## Product Change Notification

### Bourns® Model 3329P-DK9, PV32P, RJ50, and RJR50 Round Trimming Potentiometers *Change to Packaging Tube*

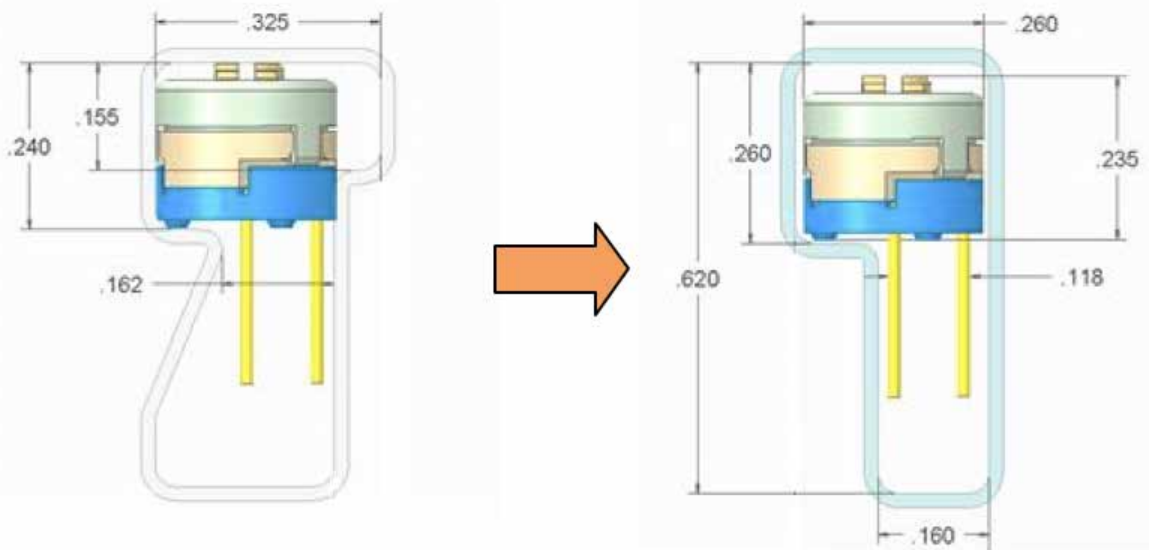
Bourns is pleased to announce an upgrade to the packaging tubes for the [Model 3329P-DK9](#), [PV32P](#), [RJ50](#) and [RJR50](#) Round Trimming Potentiometers. The new packaging tube will be shaped much like the trimmer itself, rather than the less efficient shape that is currently being used.

There are no changes to the form, fit, function, quality or reliability of the trimmers themselves. The packaging tube's fit (physical dimensions) and form (the appearance, such as the shape) will be changed. A list of the affected part numbers is shown in Table 1 on the next page.
